# REPORT TO DESIGN COMMISSION City of Sacramento

**PUBLIC HEARING**  
**October 13, 2010**

**Subject: 3820 Broadway (P10-042)** Located at the southeast corner of Broadway and Martin Luther King Jr, Boulevard, a request to develop a three story 56 unit residential with ground floor retail on 1.2+/- acres in the Broadway/Stockton and Oak Park Special Planning District (C-1-SPD) zone.

BROADWAY ENLARGED ELEVATION - CORNER PLAZA | OPTION A

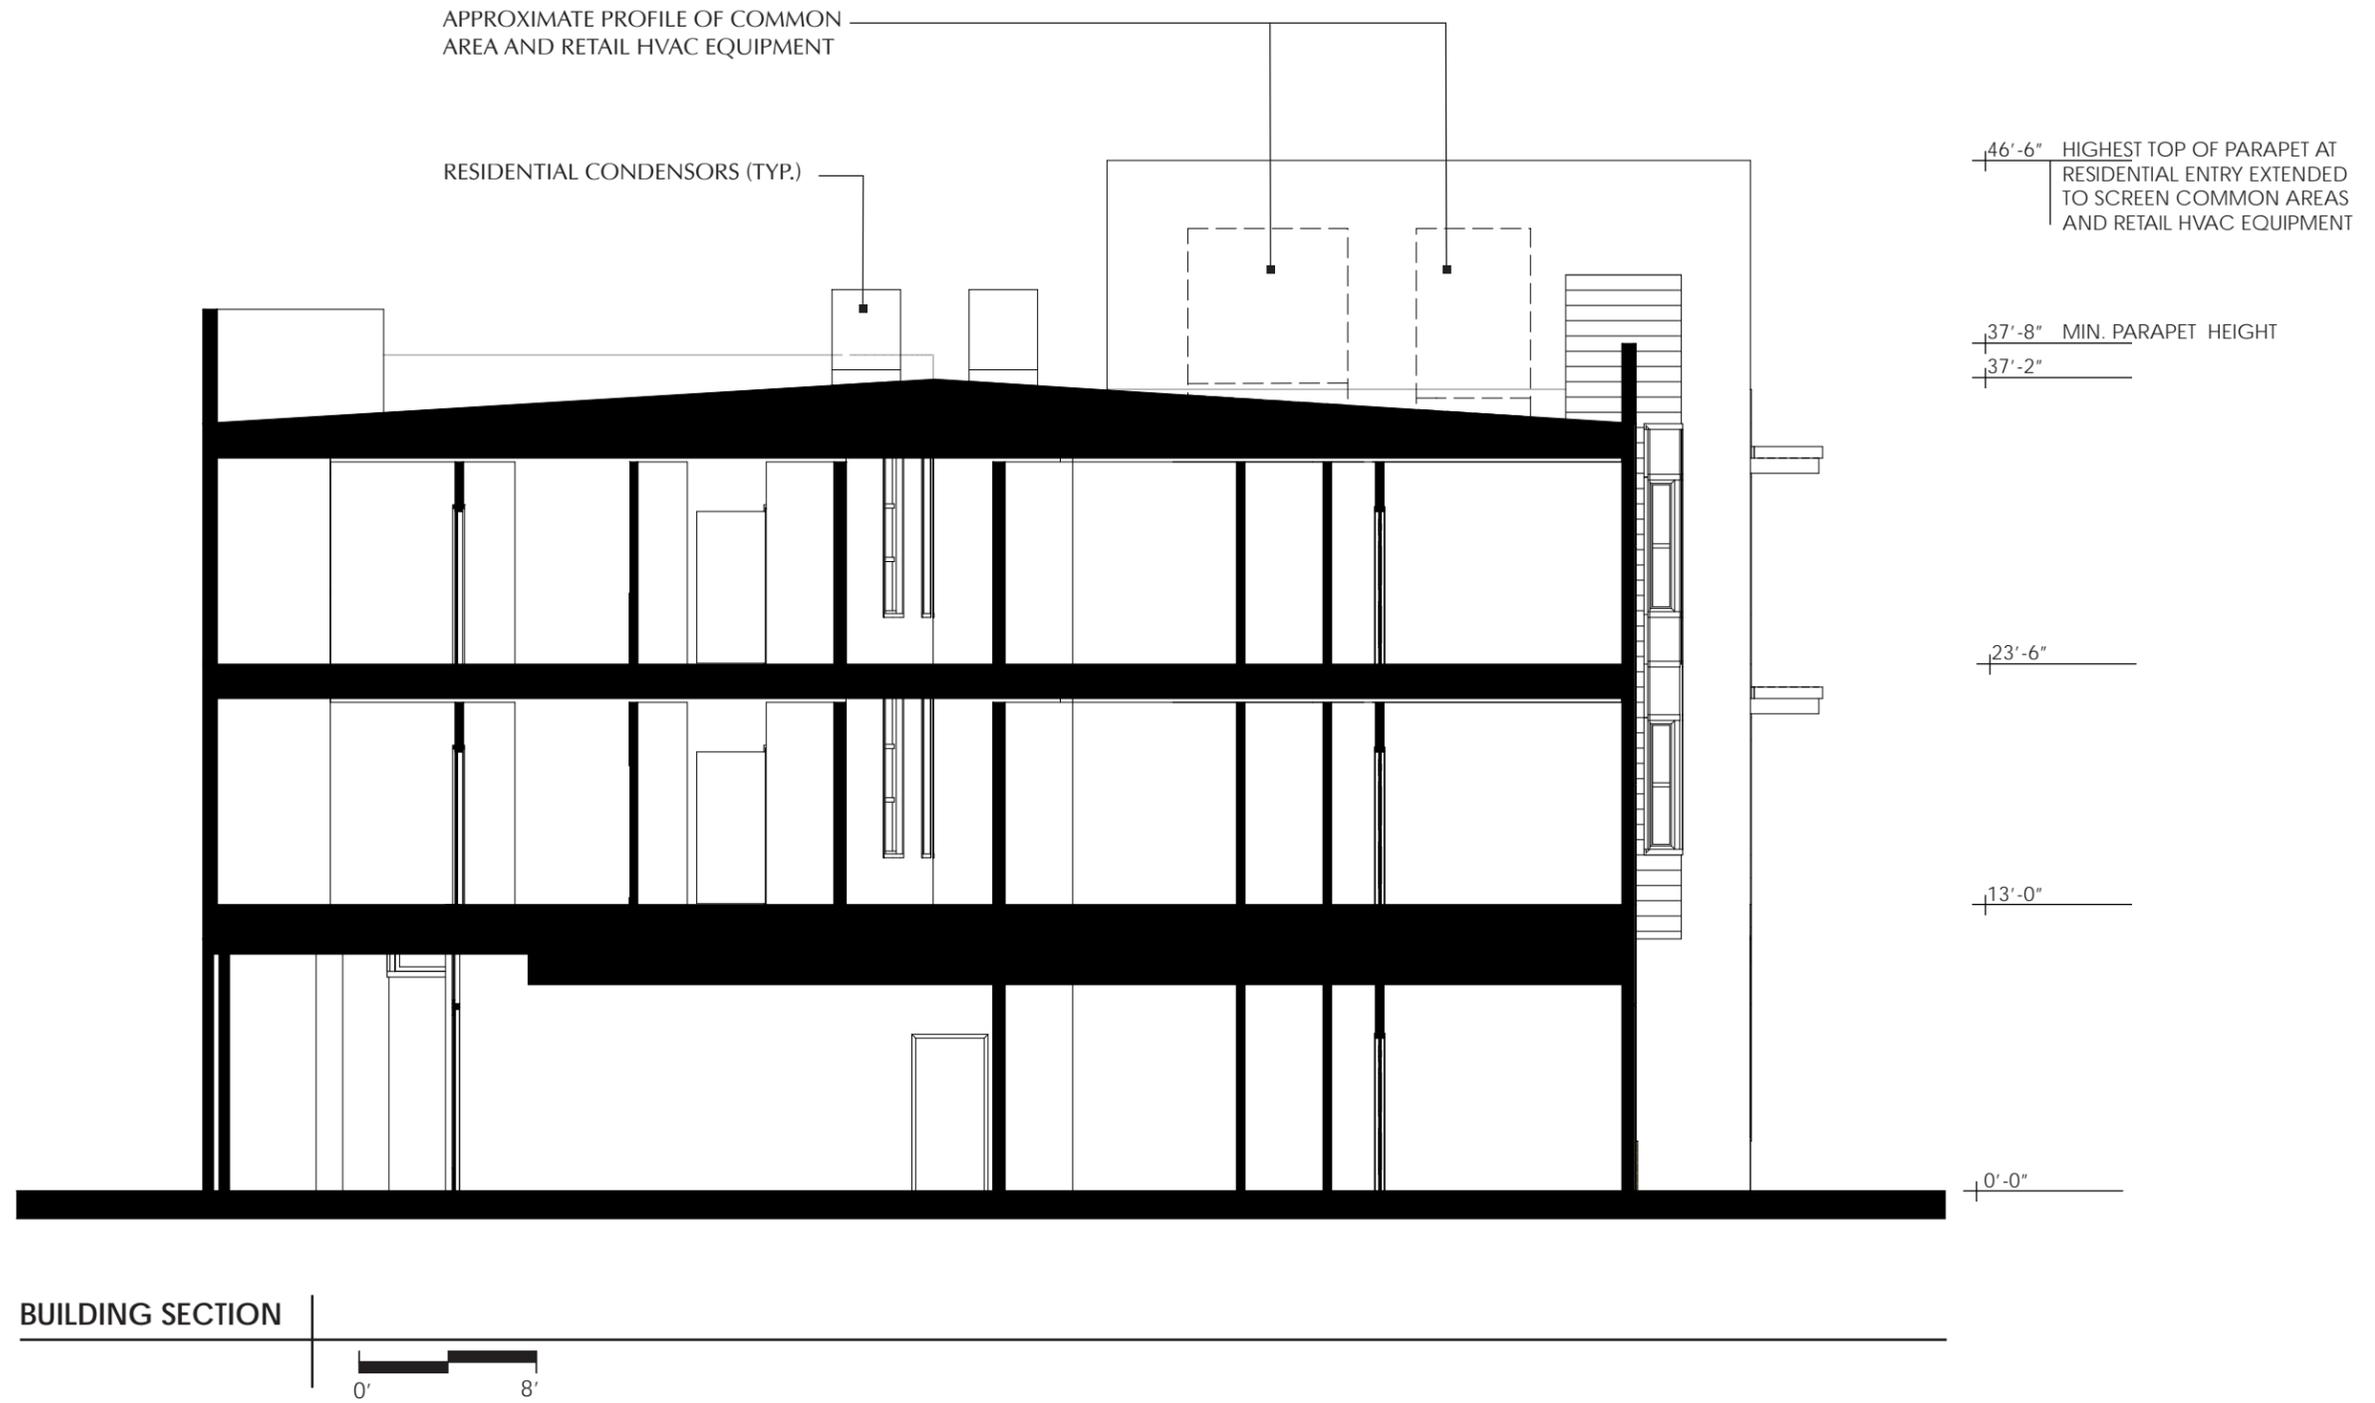
10. Due to the fast turnaround time, the corner element issues have not been resolved, **but staff has been working with the design team and owner since the previous Review and Comment Hearing and feels that corner element has evolved past the previous issues with some exceptions. SHRA, the Design Team and City Staff have agreed that the two story height of the loggia is appropriate for the site conditions and program requirements, but the final articulation and integration of the column design, loggia soffit, and third story cornice are critical to a successful corner. Staff is supportive of the Option A column design, and the cornice design of Option B. Staff feels that the soffit should be inset and recessed in order to emphasize the column connection and importance of the loggia. The applicant has provided several examples of classically styled loggia, and staff feels that a modern interpretation of the recessed soffit would strengthen the two story loggia volume. Staff recommends that the applicant provide a reflected ceiling plan of the loggia and a thumbnail cross-section of the soffit and column interaction at the hearing. In order to distinguish this corner separately from the US Bank Building on Broadway, Staff recommends further refinement of third floor awning, so as not to appear as a direct interpretation of dentil molding. The awning may benefit from the same awning/sunshade style and materials provided along the Martin Luther King, Jr. façade.** ~~The corner issue includes the use of brick, location and integration of columns, changes to column bases and capitals, and locations and design of bollards. The applicant has provided two options for the column base design and staff recommends Option B which includes a lower round base. Applicant should provide revised corner element detail at the hearings.~~

ROOF PLAN  
29 SEPTEMBER 2010

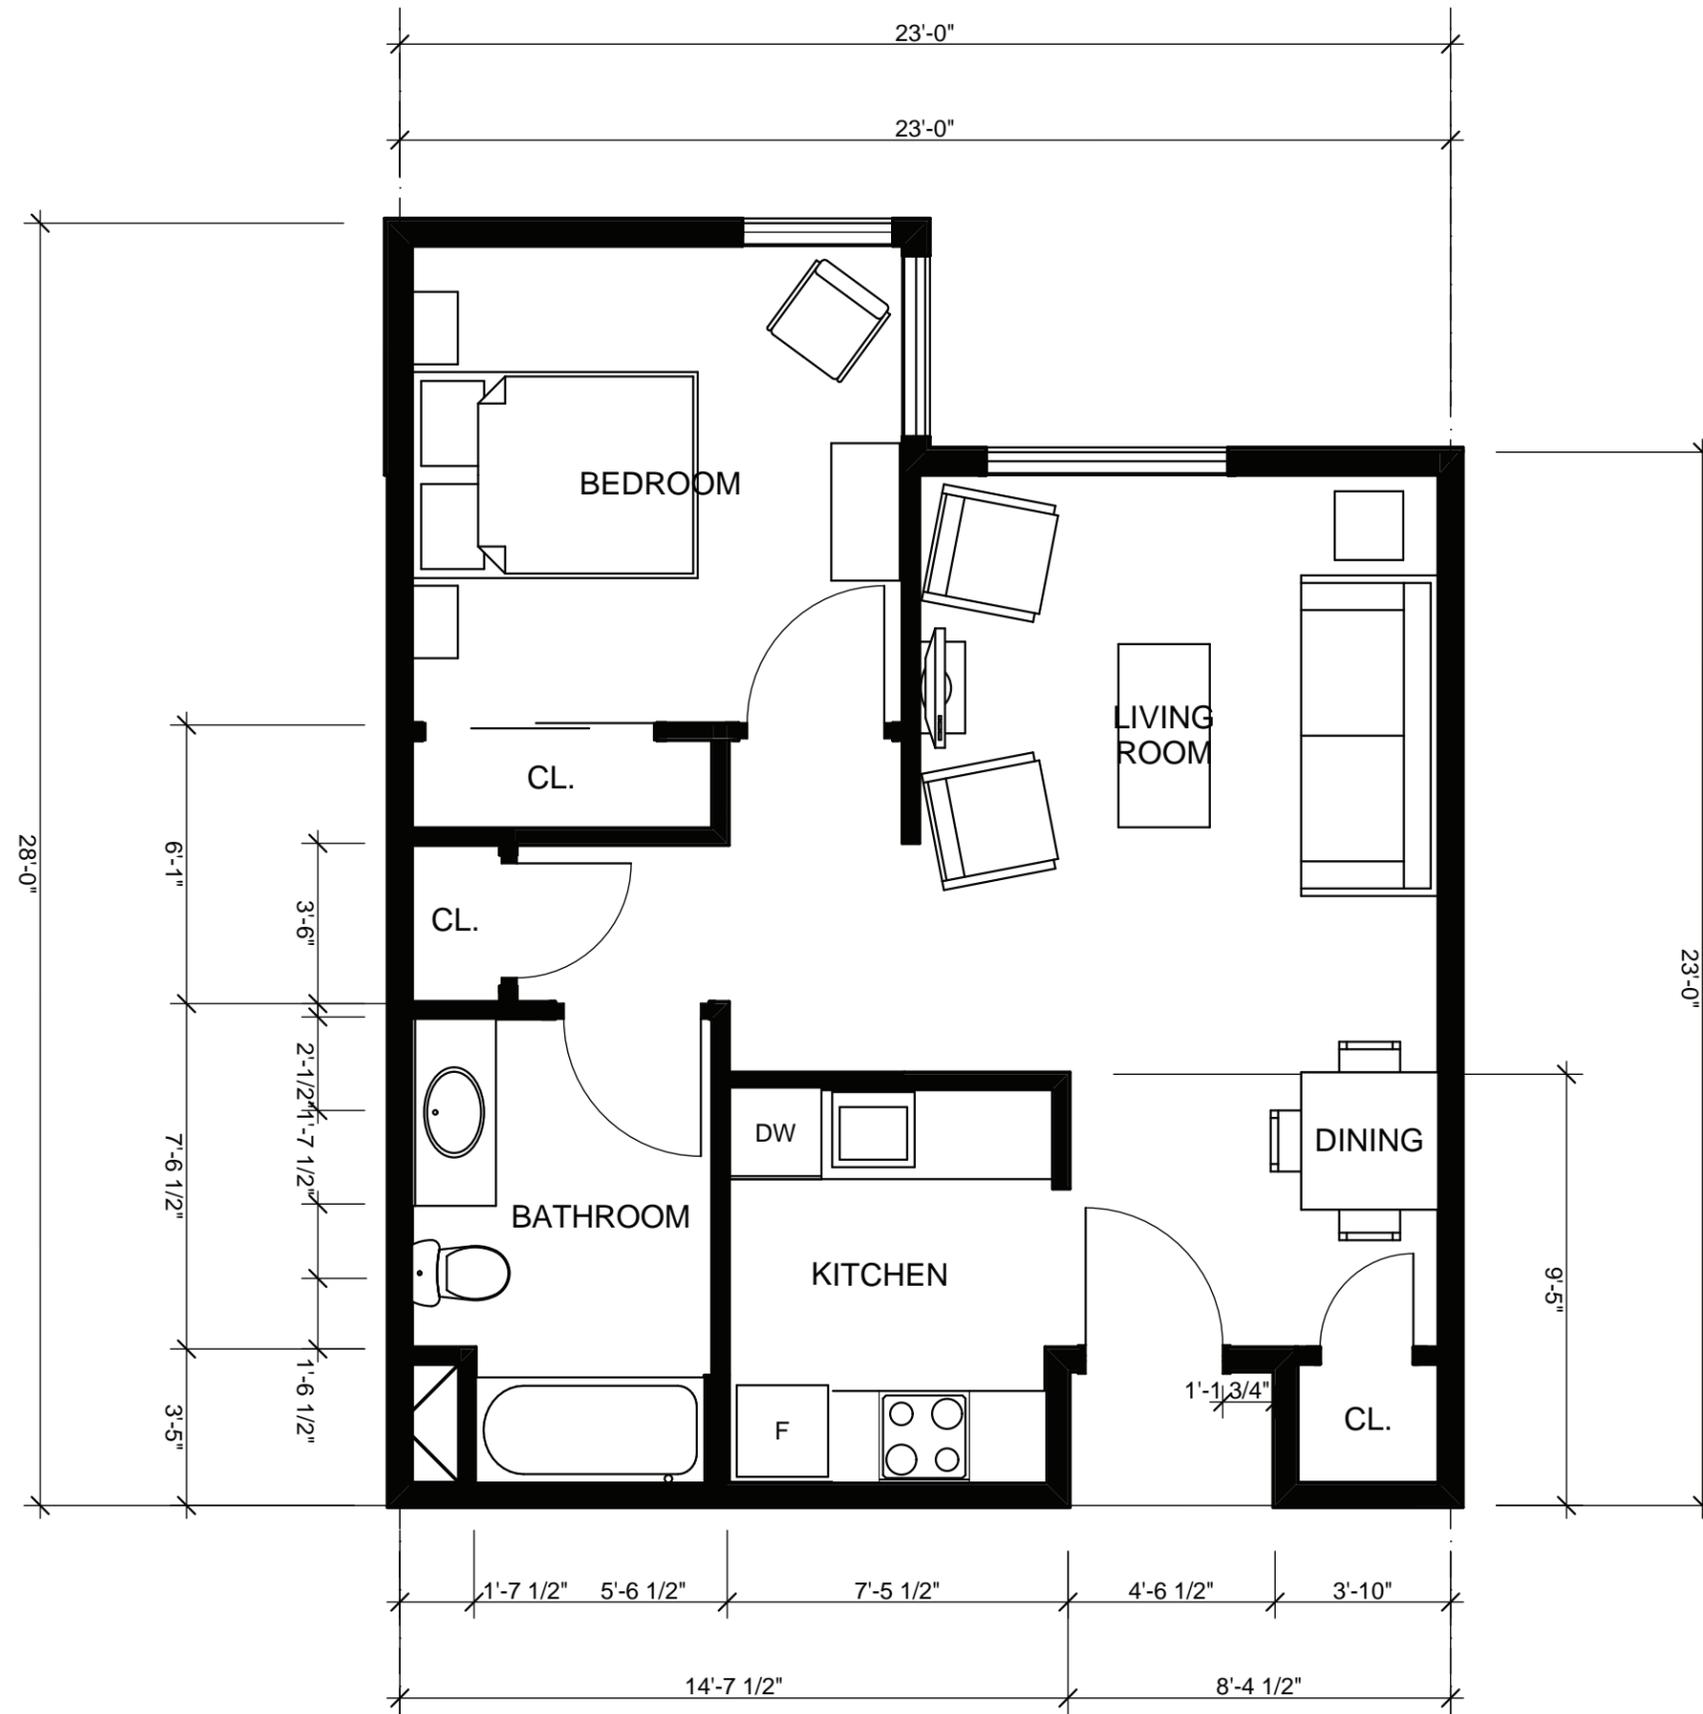
13. The applicant provided staff with a roof plan and cross-section regarding the mechanical system locations and heights. Staff is supportive of the HVAC locations as the small units will have minimal height and hidden behind the parapet, and the larger common space units will be located behind the entry parapet.

25. The common residential area HVAC system shall be incorporated within the main entry parapet and the residential unit HVAC systems shall be located behind the parapet wall, so as not to be visible from any street views. **Final roof plan with mechanical equipment locations, a section through the HVAC unit and building, and cut sheets shall be reviewed and approved by Design Review staff prior to Building Permit submittal.**

**PRELIMINARY LANDSCAPE PLAN**  
ED HAAG, LANDSCAPE ARCHITECT (916) 396-1861

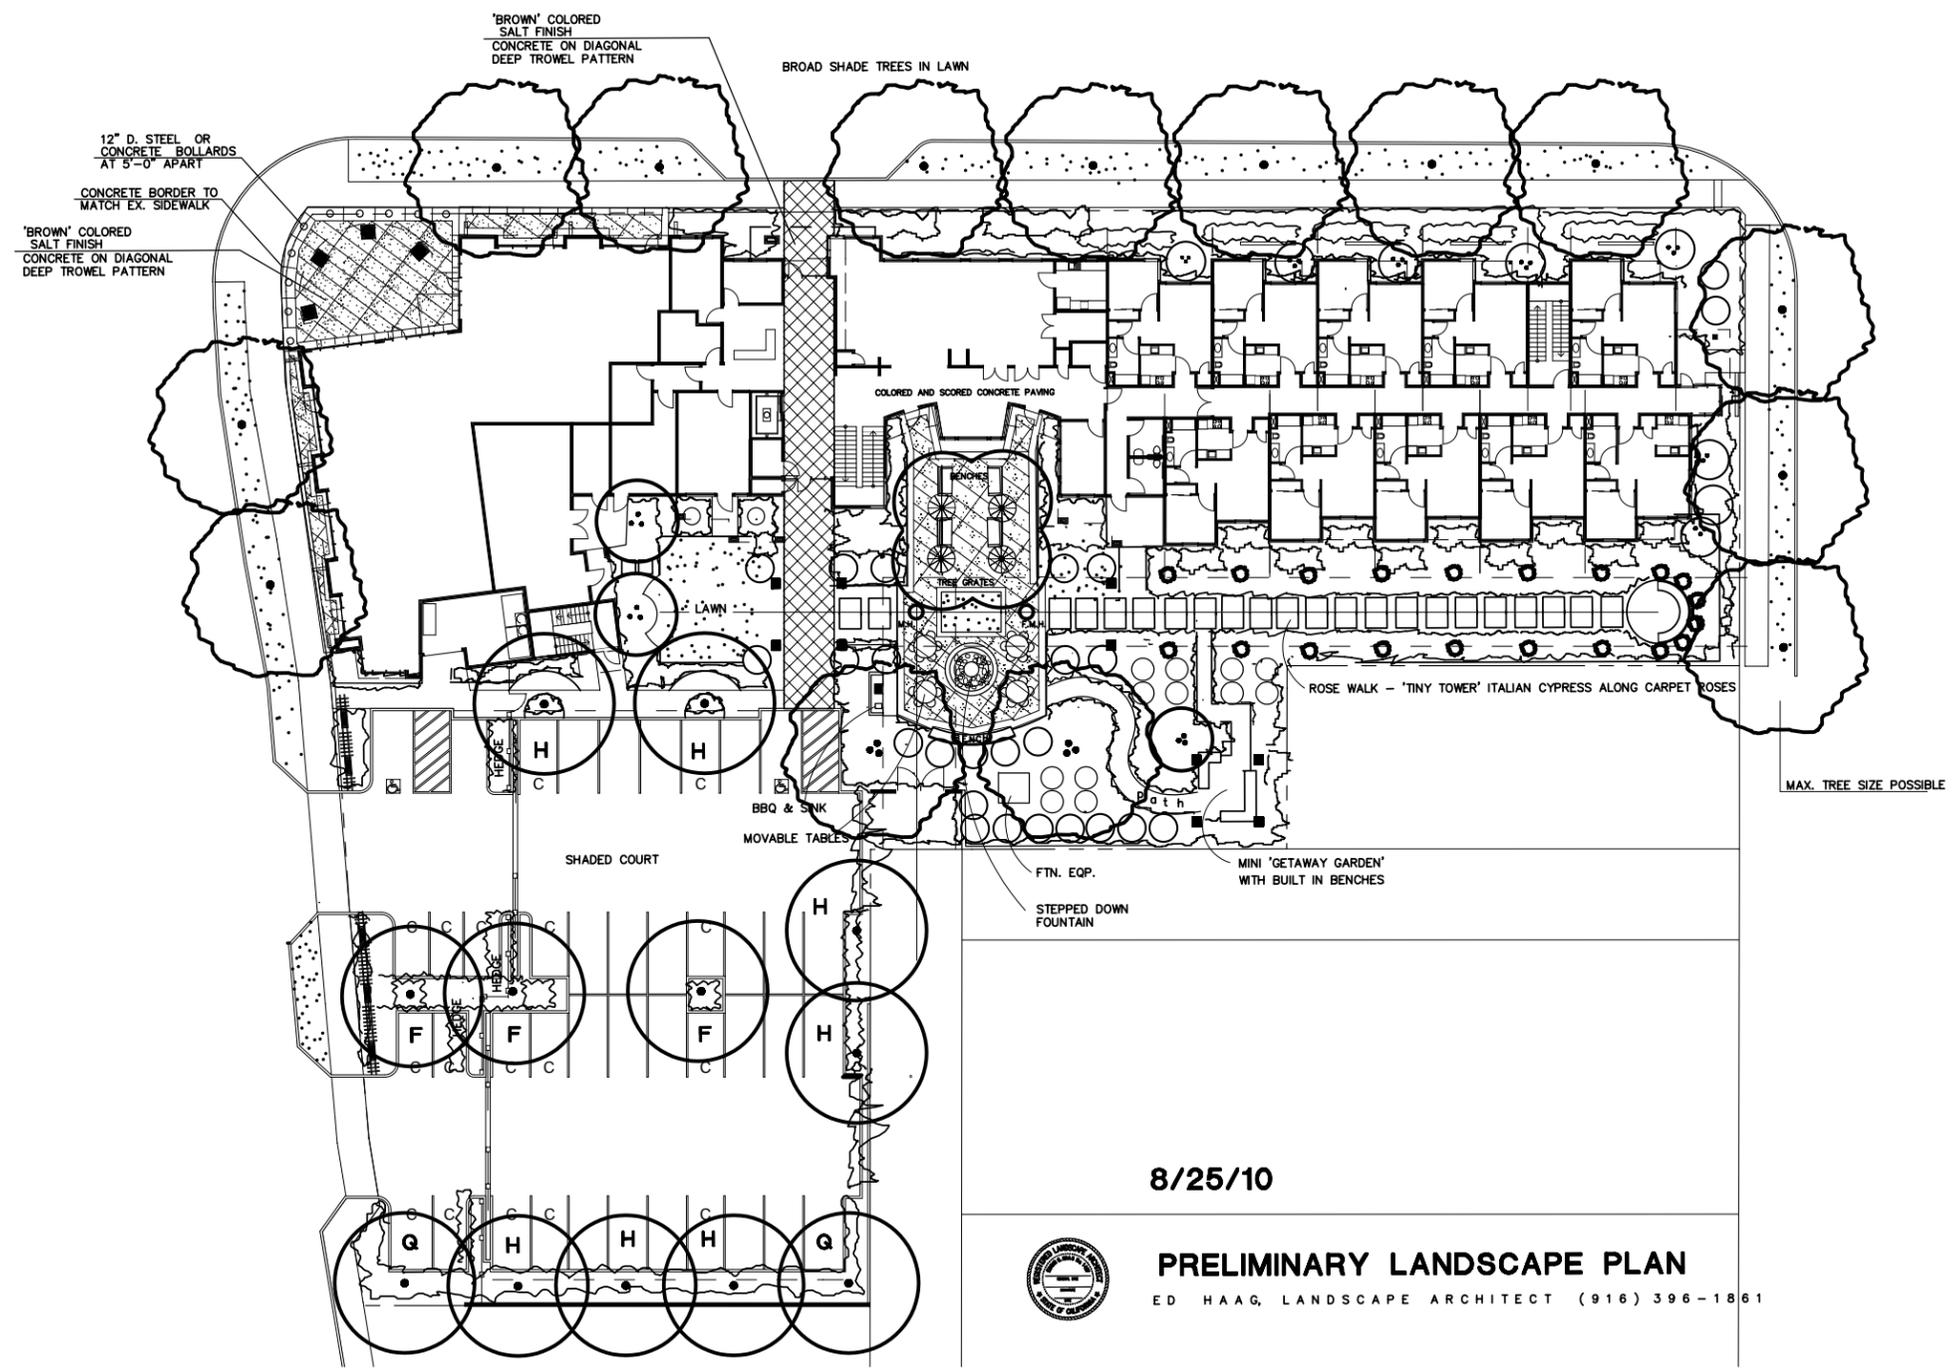
5. A separated sidewalk and generous street planters have been provided to replace the existing sidewalks. The applicant has provided additional landscaping along the Broadway elevation at the main pedestrian entry and both in front of and behind the residential separation walls. The largest possible canopy trees have been called out for 39<sup>th</sup> Street street edge, and the applicant will work with Urban Forest staff on final determination on species. The parking area has been reconfigured to provide 50.5% shading ratio, and conforms to the 50% shading requirement for parking. Staff is supportive of the revisions to the landscaping and parking shading.
